SPOKES' ADDITIONAL DETAILED COMMENTS ON THE DRAFT PLANS FOR SECTION 2 OF THE CCWEL

Comments on points made in Rurighd McMeddes' email of 18 July

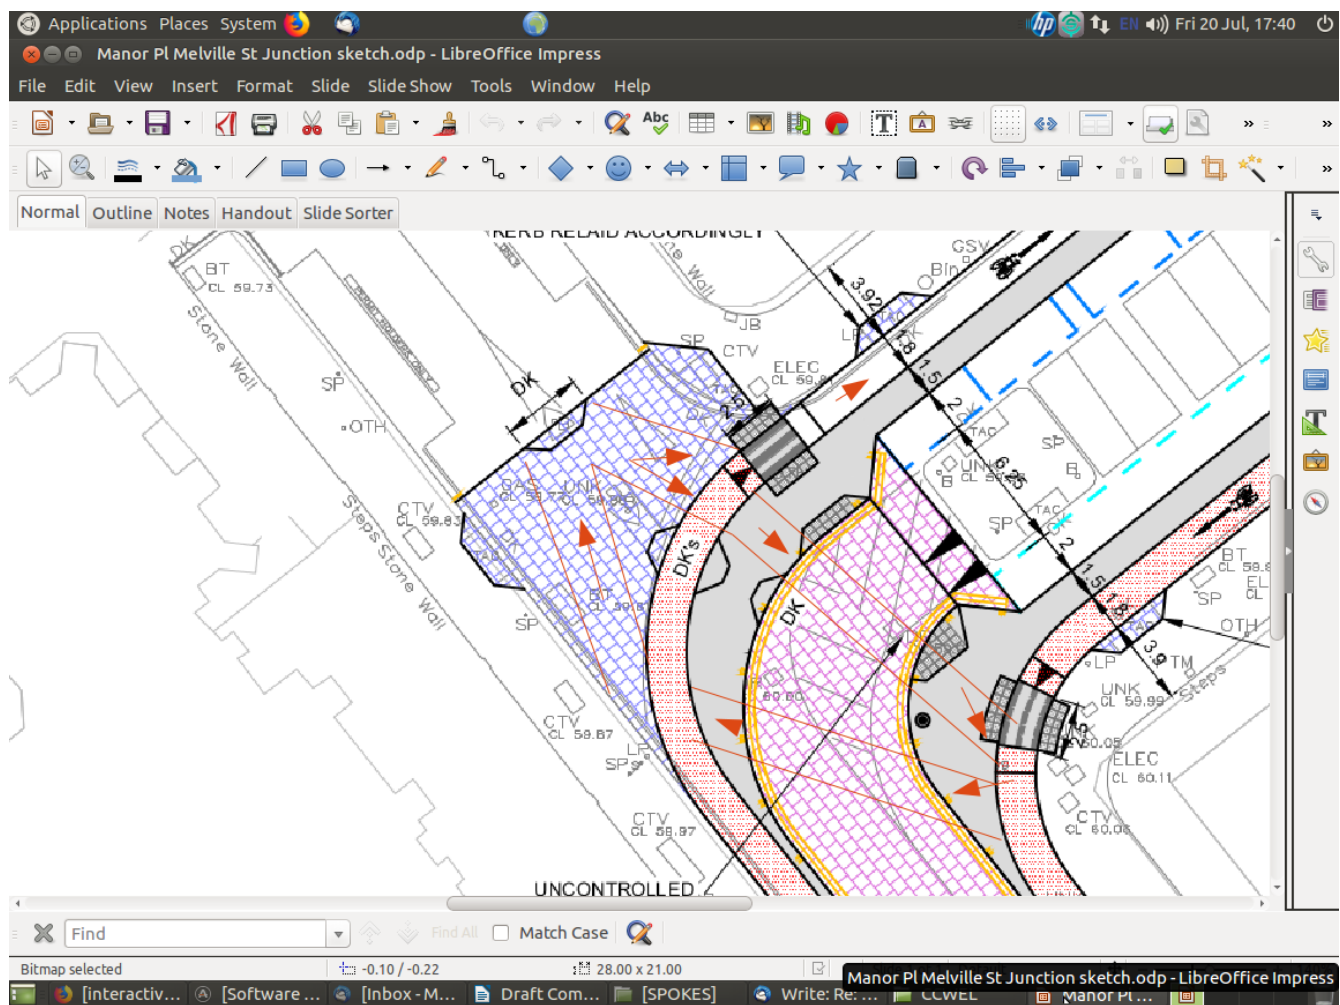
We are pleased that this junction is being reviewed. *We recommend that it would be logical to extend the layout of cycle lanes to cover all turns, rather than have some relying on the use of shared use space.* There needs to be improved arrangements for cyclists travelling to and from the north of Manor Place i.e. beyond the road closure, including provision for:

- cyclists travelling from east to west along Melville St who wish to make a right turn into the north end of Manor Place
- cyclists wishing to turn from the north end of Manor Place into the west east cycleway along Melville St
- cyclists from north Manor Place who wish to join the cycleway going south along Manor Place
- northbound cyclists on Manor Place who wish to continue on along Manor Place.

We have set out below a rough illustrative diagram which shows the routes we have in mind. We suggest that you consider having designated cycle lanes (possibly marked with white lines or coloured where these cross the carriageway) quite separate from the proposed pedestrian crossing, with give-way lines at the road itself. Where these lanes cross the proposed build outs and buffer areas at this junction they should be at the same level as the cycleway itself to avoid the need for dropped kerbs.
